Docket: PROJ0769

SUBJECT: NuScale Power, LLC Submittal of NuScale Preliminary Concept of Operations Summary and Response to NRC Questions on Control Room Activities (NRC Project No. 0769)

Response to NRC Questions Related to Control Room Activities

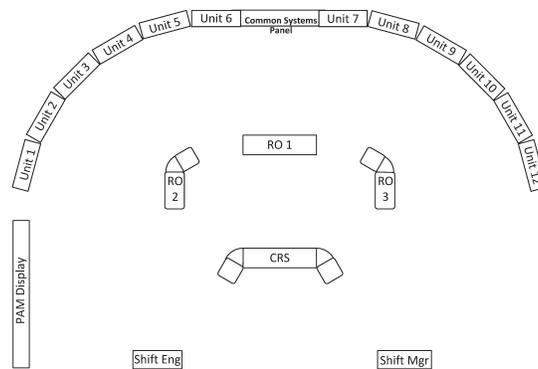
1. How is control room staff monitoring the status of the reactors? Is one operator assigned to one or more reactors? Is the assignment this dedicated?

Initial staffing levels for a 12-unit NuScale plant will be six licensed operators: three Senior Reactor Operators (SROs) and three Reactor Operators (ROs). The SROs consist of a Shift Manager, Control Room Supervisor, and a Shift Technical Advisor all of whom will have roles similar to those in existing U.S. commercial nuclear power plants. The three ROs will provide oversight of the 12 units. Normally, one licensed operator, the lead RO, will be assigned responsibility for all twelve reactors. If a module is in an off-normal condition or involved in a complex evolution, then the module may be assigned to a separate licensed operator. The assignment of a reactor to an operator is dedicated until relieved of that responsibility. During significant planned evolutions, maintenance, and modifications, the normal control room complement will be augmented by additional licensed operators.
